## ADDENDUM NO. 2

DATE: February 10, 2025

PROJECT: ORCHARD VALLEY GOLF COURSE BRIDGE REPLACEMENTS

FROM: Engineering Enterprises, Inc.  
52 Wheeler Road  
Sugar Grove, Illinois 60554

DATE:	JANUARY 2025
PROJECT NO.:	PD2302
FILE:	PD2302-GRADE
SHEET	<b>C16</b> OF <b>C30</b>

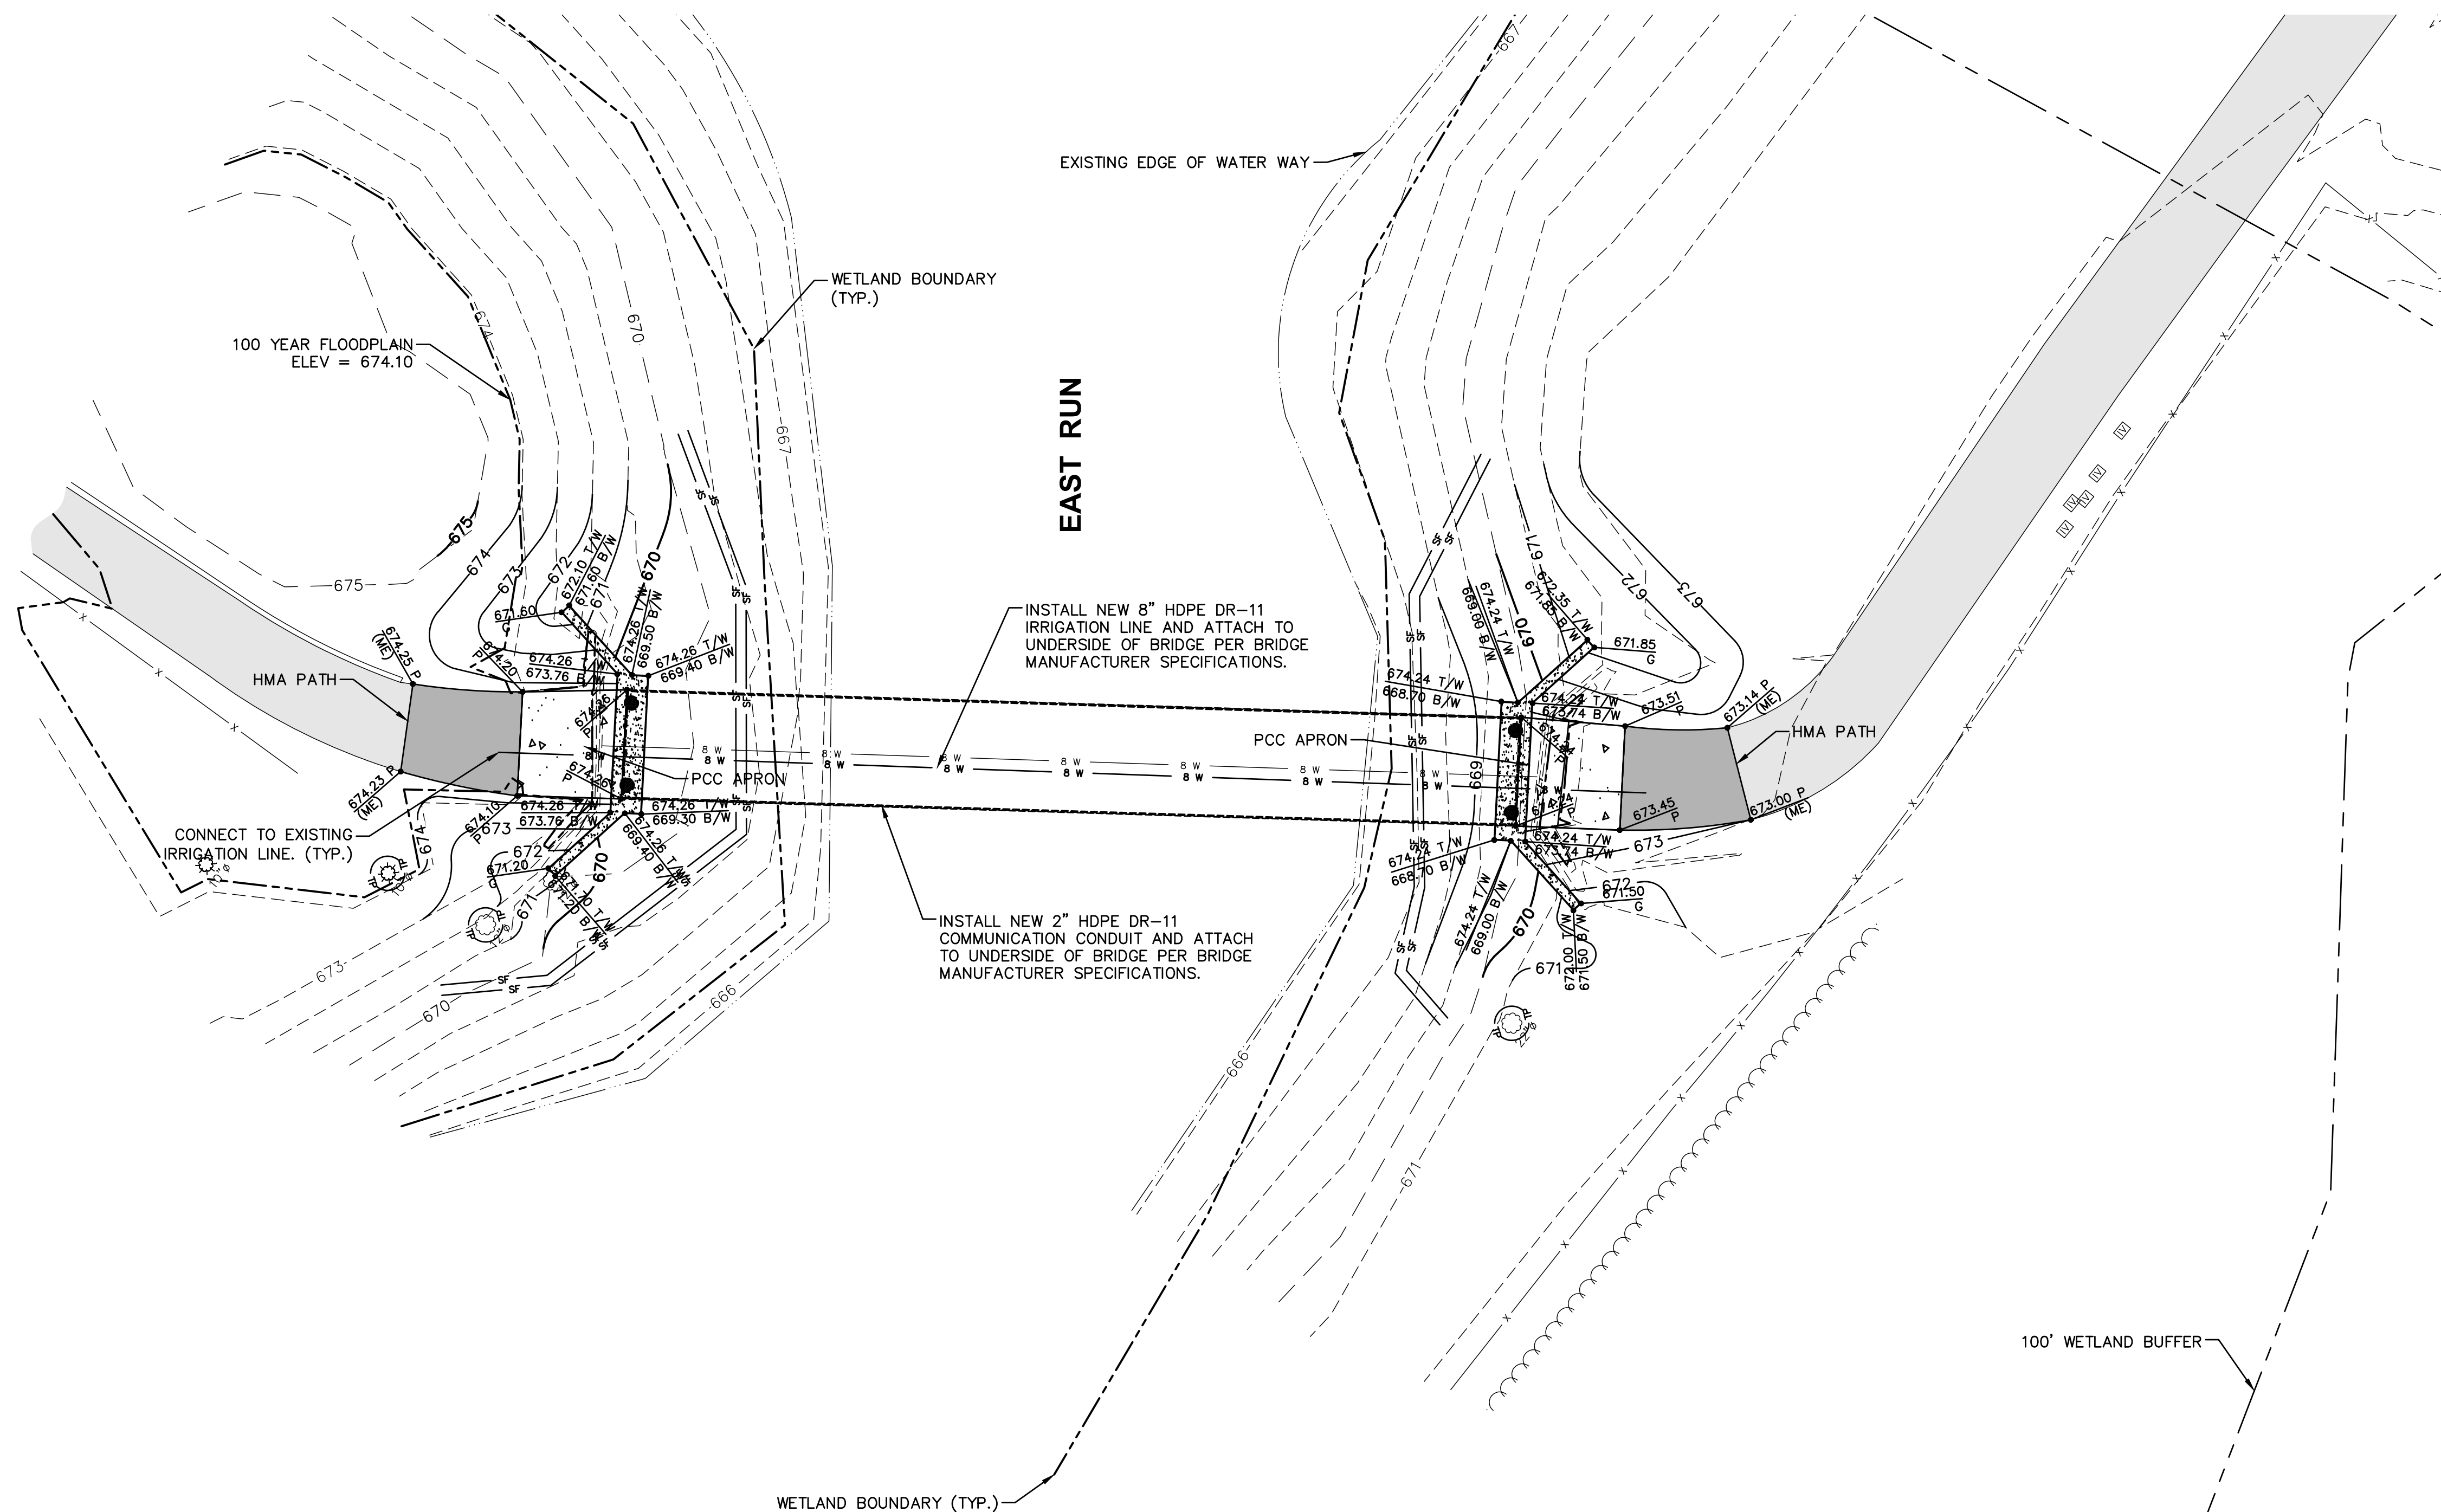
26. Civil plan sheets C16, C17, C18, C19, C20, and C21 have been revised for additional water line information and based on contractor questions. Structural plan sheets S2, S10, S11, and S12 have been revised based on contractor questions. All revised sheets are included with this addendum.

INSTALL NEW 8" HDPE DR-11 IRRIGATION LINE AND ATTACH TO UNDERSIDE OF BRIDGE PER BRIDGE MANUFACTURER SPECIFICATIONS.

INSTALL NEW 2" HDPE DR-11 COMMUNICATION CONDUIT AND ATTACH TO UNDERSIDE OF BRIDGE PER BRIDGE MANUFACTURER SPECIFICATIONS.

CONNECT TO EXISTING IRRIGATION LINE. (TYP.)

DATE: JANUARY 2025
PROJECT NO: PD2302
FILE: PD2302-GRADE
SHEET <b>C19</b> OF <b>C30</b>

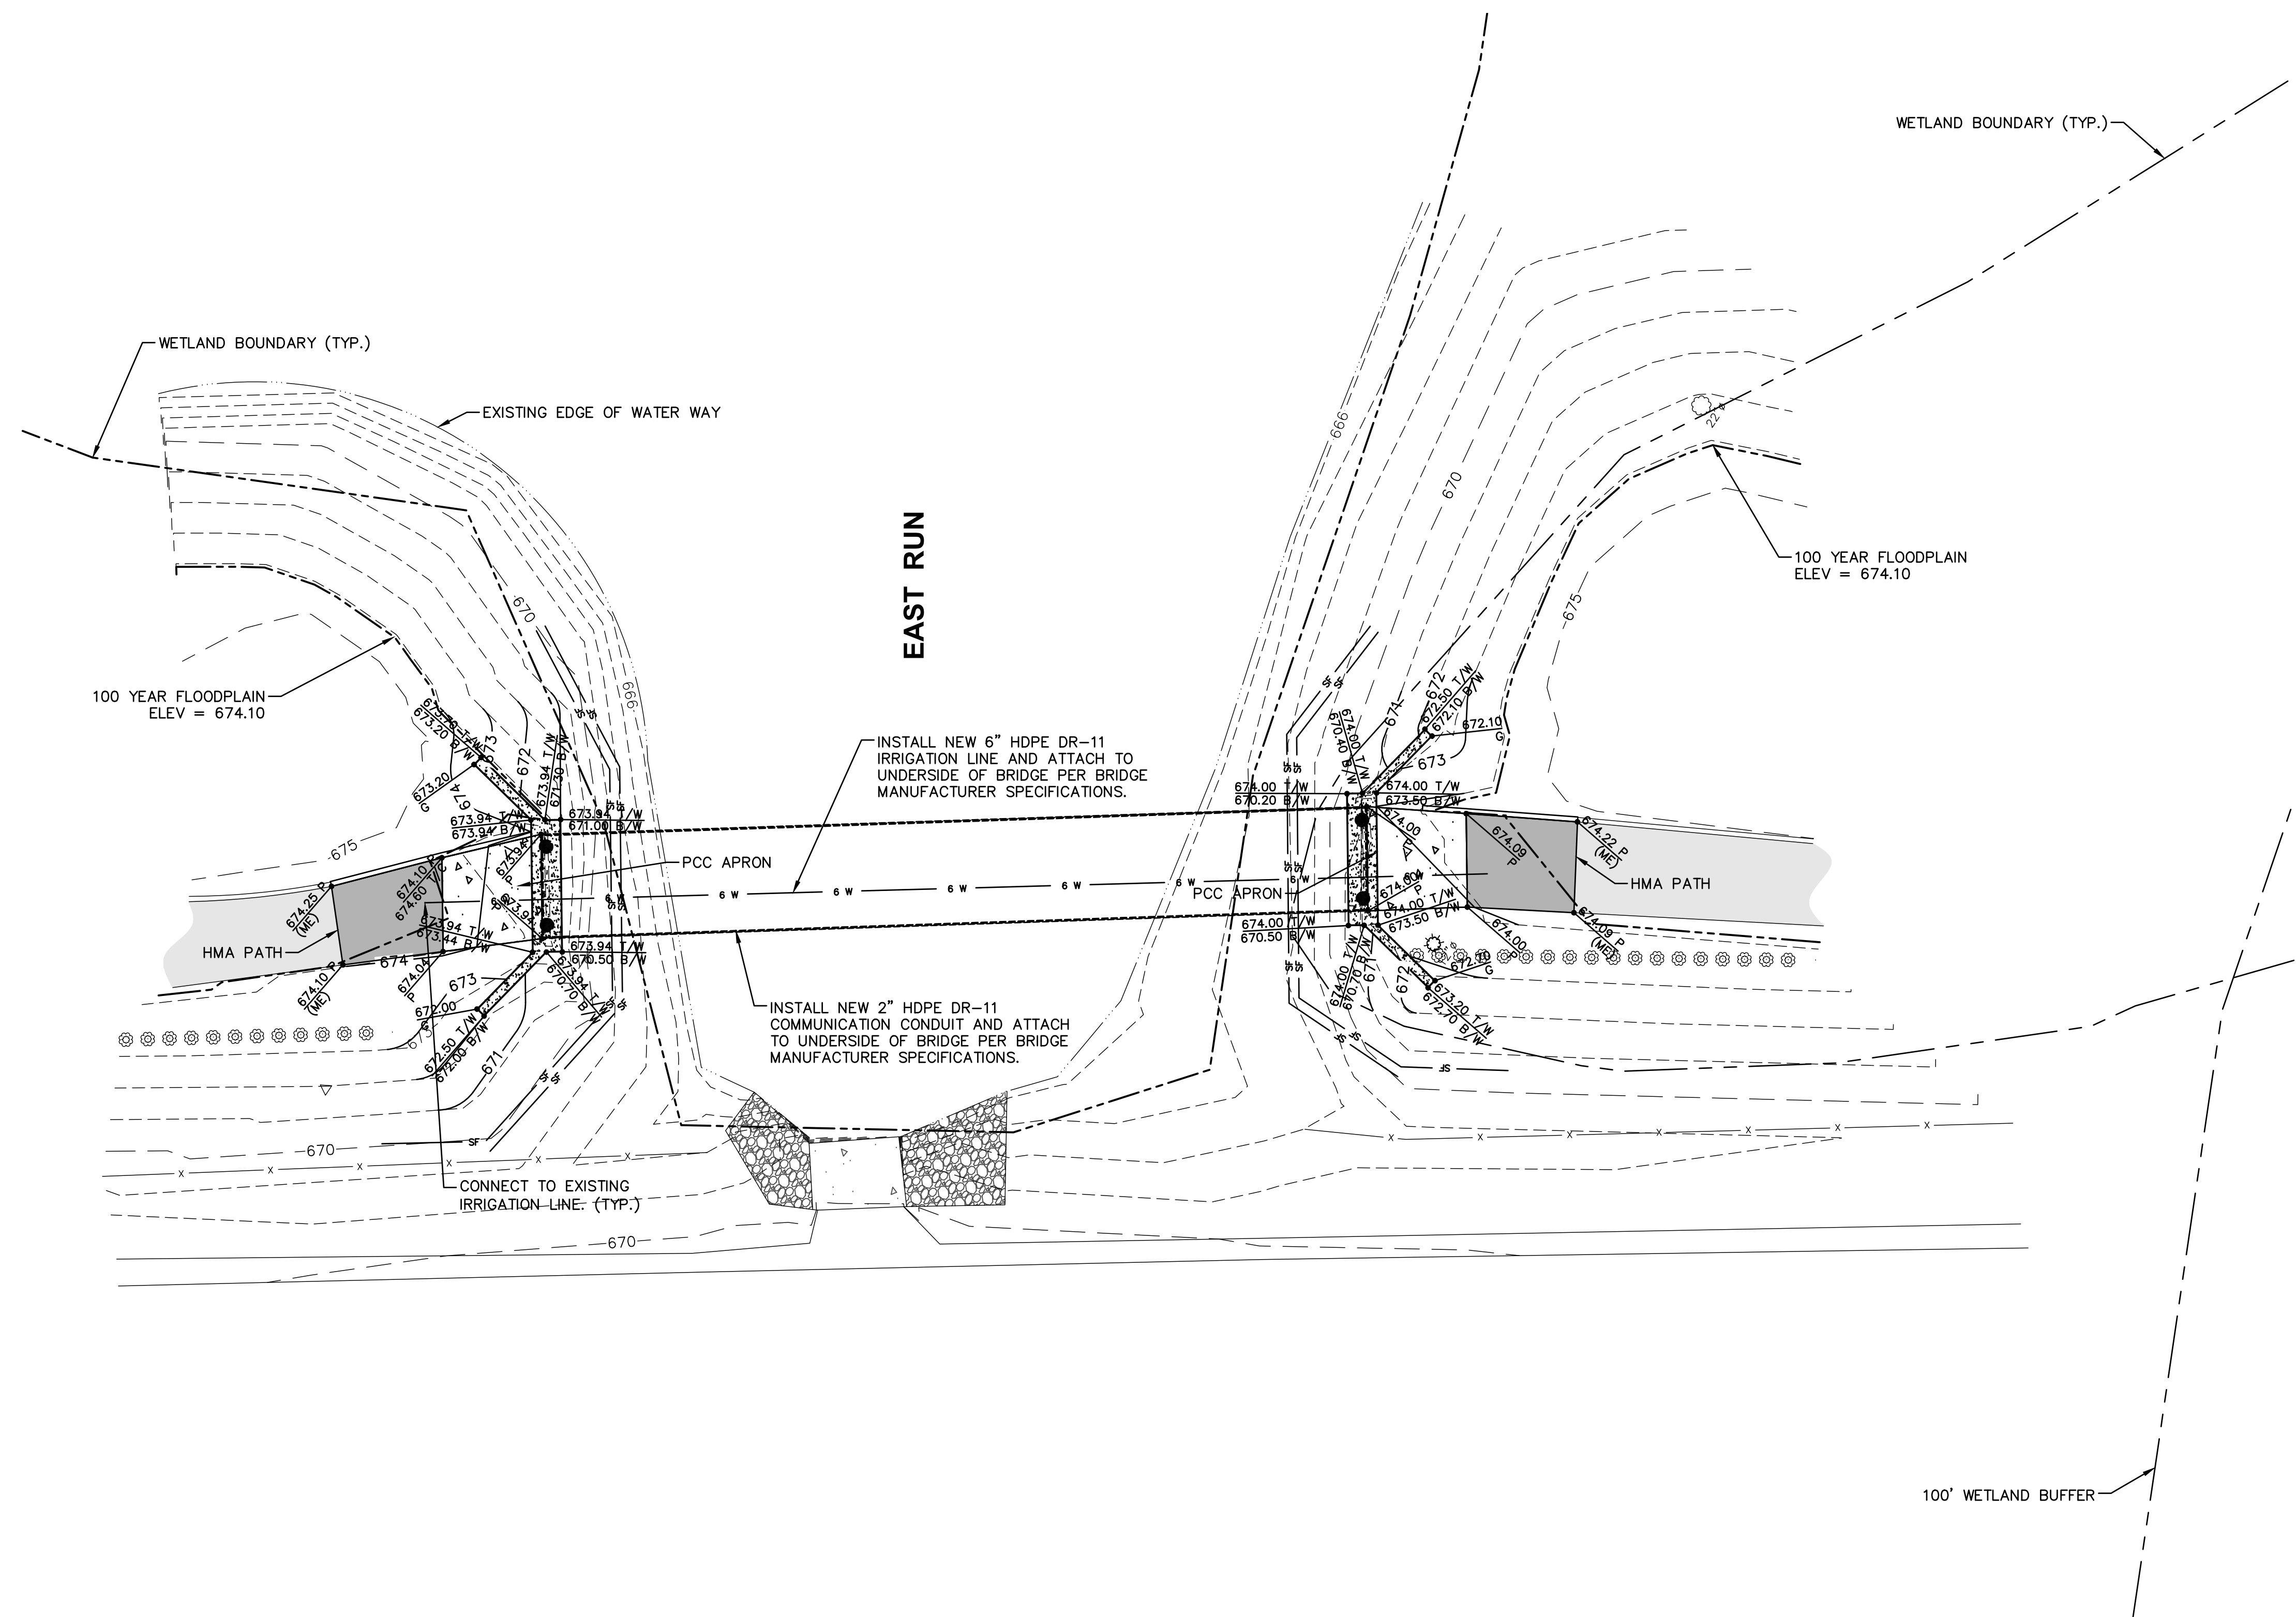
INSTALL NEW 6" HDPE DR-11  
IRRIGATION LINE AND ATTACH TO  
UNDERSIDE OF BRIDGE PER BRIDGE  
MANUFACTURER SPECIFICATIONS.

INSTALL NEW 2" HDPE DR-11  
COMMUNICATION CONDUIT AND ATTACH  
TO UNDERSIDE OF BRIDGE PER BRIDGE  
MANUFACTURER SPECIFICATIONS.

CONNECT TO EXISTING  
IRRIGATION LINE (TYP.)

DATE:	JANUARY 2025
PROJECT NO.:	PD2302
FILE:	PD2302-GRADE
SHEET	<b>C20</b> OF <b>C30</b>

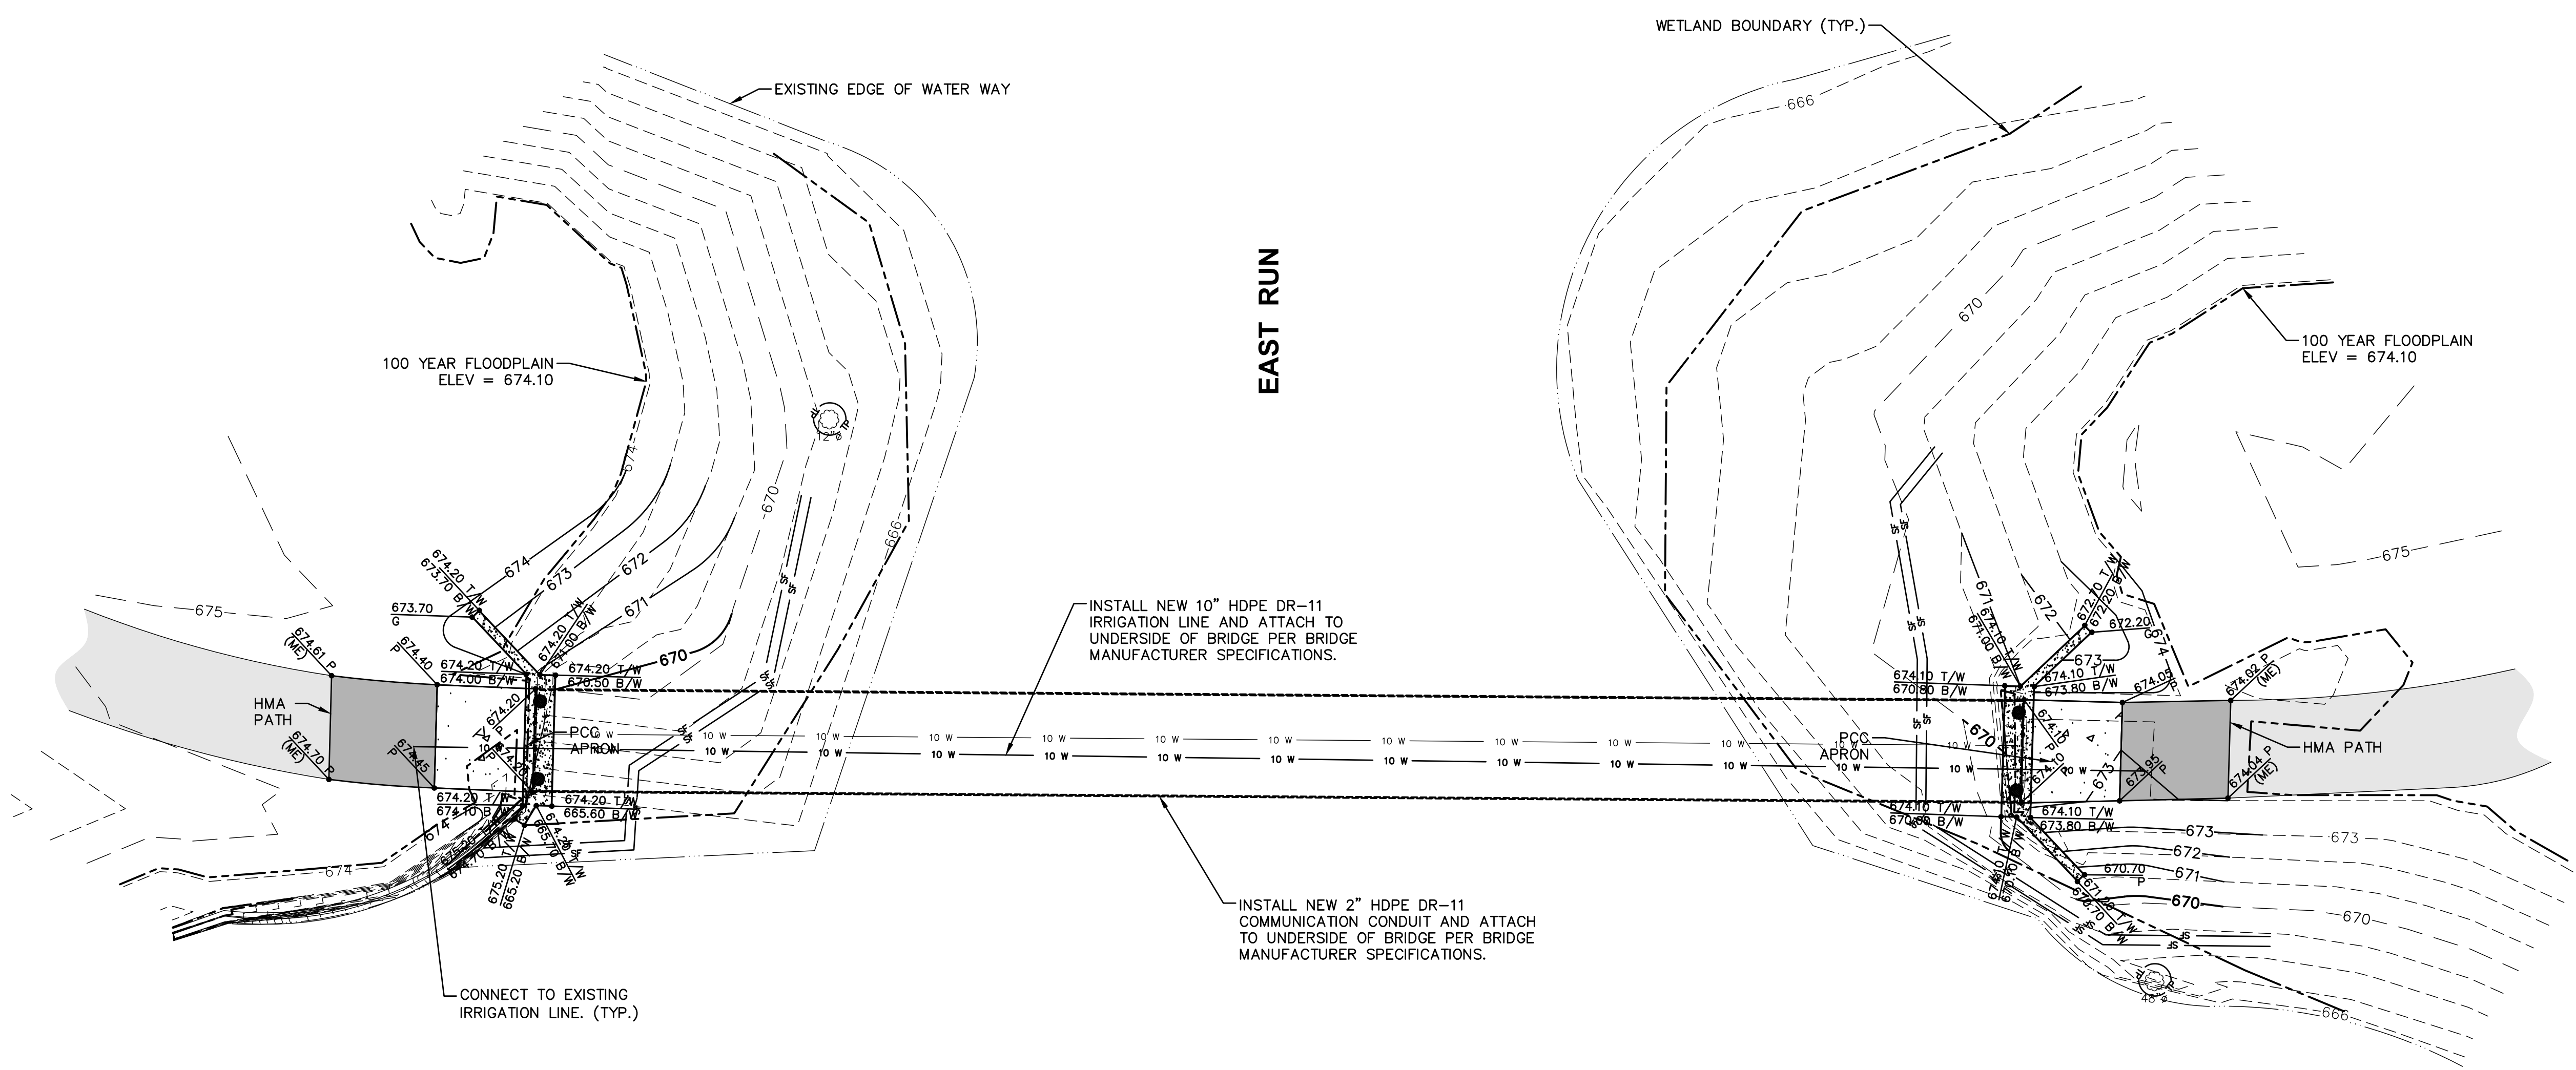
INSTALL NEW 10" HDPE DR-11 IRRIGATION LINE AND ATTACH TO UNDERSIDE OF BRIDGE PER BRIDGE MANUFACTURER SPECIFICATIONS.

INSTALL NEW 2" HDPE DR-11 COMMUNICATION CONDUIT AND ATTACH TO UNDERSIDE OF BRIDGE PER BRIDGE MANUFACTURER SPECIFICATIONS.

CONNECT TO EXISTING IRRIGATION LINE. (TYP.)
